**PLANNED UNIT DEVELOPMENT  
& SUBDIVISION STAFF REPORT****Date: July 7, 2016****DEVELOPMENT NAME**

Holcombe Avenue Subdivision, Mosley's Addition to

**CONTEMPLATED USE**Planned Unit Development Approval to allow multiple  
buildings on a single building site and Subdivision  
Approval to create 1 legal lot of record from several  
existing legal lots.**TIME SCHEDULE  
FOR DEVELOPMENT**

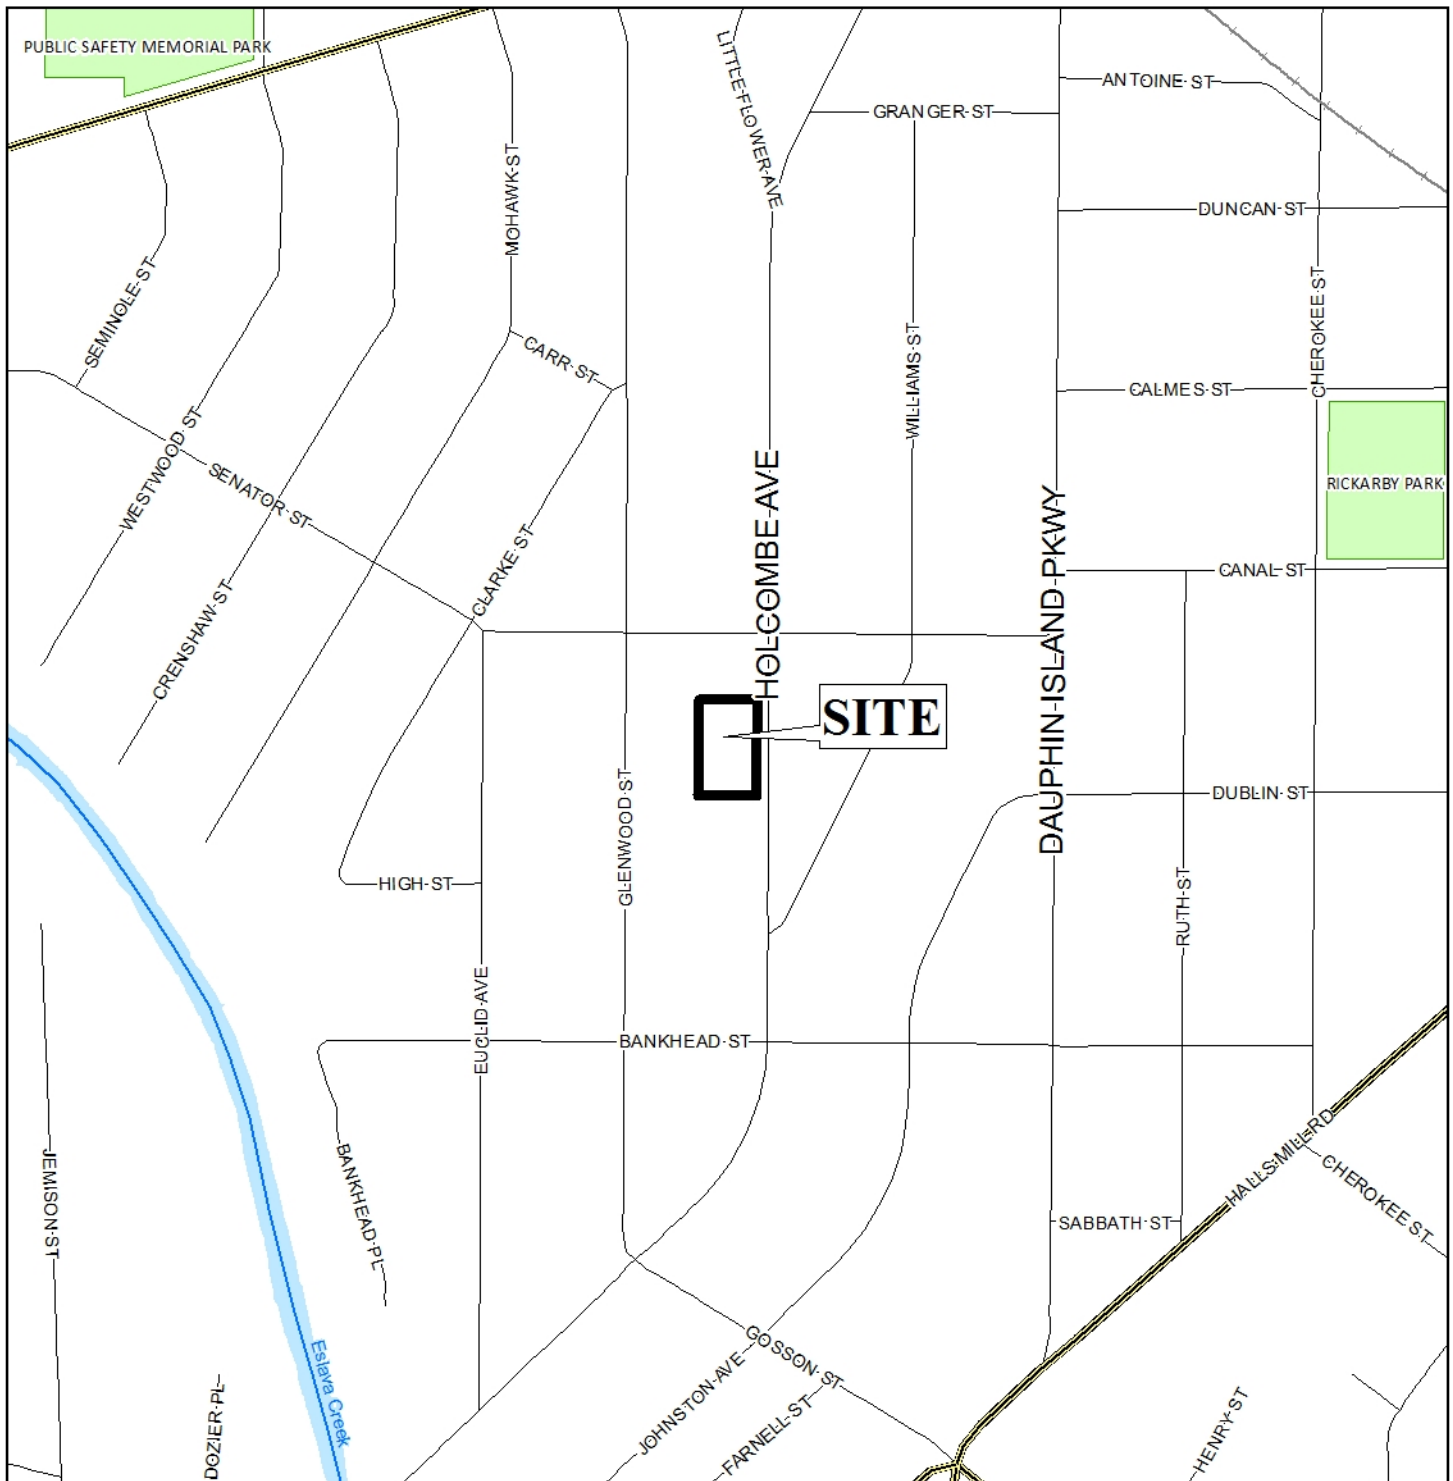
The 25-foot minimum building setback line, required in Section V.D.9., is shown for the subdivision, but is not depicted on the site plan. The site plan should be revised to depict the 25' minimum building setback line.

In regards to tree and landscaping, the site must be brought into full tree and landscaping compliance. There is a note on the site plan stating "*frontage trees and perimeter trees will be provided per the tree ordinance*"; however the site plan should be revised to illustrate full compliance with Section 64-4.E. of the Zoning Ordinance regarding tree and landscaping requirements.

The parking spaces provided on the site plan meet the minimum requirements for the office building, but do not reflect an adequate number of parking spaces to accommodate the requirements for the warehouse. The site plan should be revised to provide the number of warehouse employees and illustrate the minimum parking requirements compliant with Section 64-6. of the Zoning Ordinance.

The site plan depicts some existing asphalt on the site and what appears to be an unpaved and undeveloped area for the remaining portion of the lot. There is no indication of what that area would be used for nor is it indicated to be paved, thus raising some concern for staff. The property is zoned B-3 with existing office and warehouse space which would allow a contractor/commercial storage yard. Staff would like the applicant provide a narrative of what the unpaved and undeveloped area would be used for to verify that the parking of automobiles and storage use on the unpaved area would not occur, or revise to depict a compliant surface.

The site plan depicts what appears to be an existing privacy fence along majority of the property and an 8' block wall around the remaining portion. It should be pointed out that the portion of the existing privacy fence along the rear of the site as well as the 8' block wall is located within the alley and not on private property. Both the privacy fence and wall should be removed and relocated on private property. Due to the fact the site abuts residential zoned property a protection buffer compliant with Section 64-4.D of the Zoning Ordinance will be required where the site abuts residential zoned property. The site plan should be revised to reflect these requirements.

- 1) revision of the site plan to depict the 25' minimum setback line;
- 2) revision of the site plan to depict full compliance of Section 64-4.E. of the Zoning Ordinance regarding tree and landscaping requirements;
- 3) revision of the site plan to eliminate all unused existing curb cuts;

- 4) revision of the site plan to depict the minimum parking requirements compliant with the number of warehouse employees and Section 64-6. of the Zoning Ordinance for the office building and warehouse;

- 5) provision of a narrative and revised site plan to depict what the unpaved and undeveloped area will be used for;
- 6) revision of the site plan and preliminary plat to remove and or relocate the existing privacy fence along the rear of the site and the 8' block wall that is located within the alley;

- 7) revision of the site plan to depict a protection buffer compliant with Section 64-4.D of the Zoning Ordinance where the site abuts residential zoned property;
